**July 17, 2024**

### **COYOTE BOOSTER PUMP STATION PUMP CAN REPLACEMENT PROJECT NO. 53002**

#### **ADDENDUM NO. 1**

**COYOTE BOOSTER PUMP STATION PUMP CAN REPLACEMENT  
EXHIBIT A**

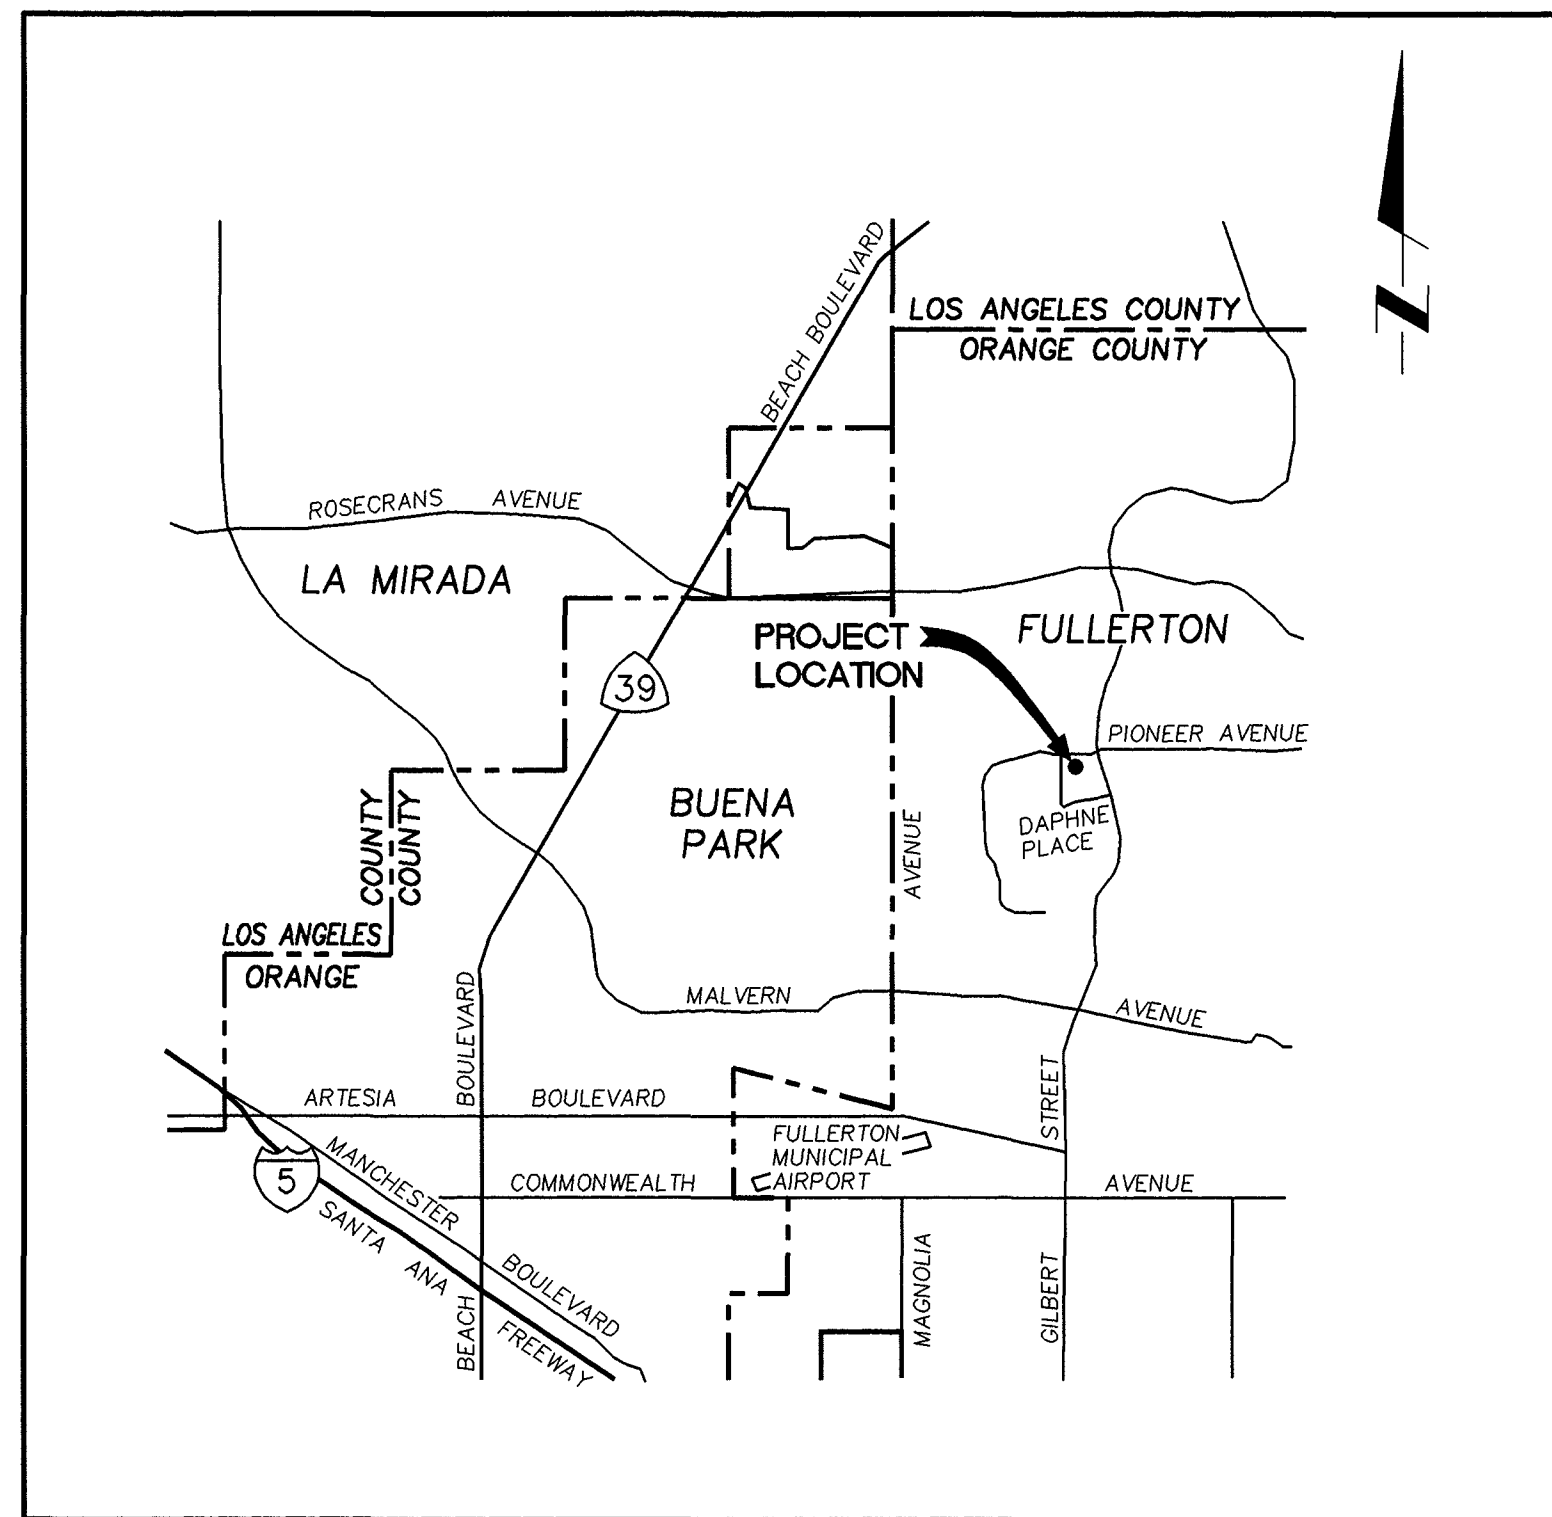
2. How much area is available at the site for a laydown yard including temporary storage of excavated materials?

Response: See Exhibit A attached. The Contractor will be required to provide continuous access to the existing pump station and around the existing reservoir for City operations staff.
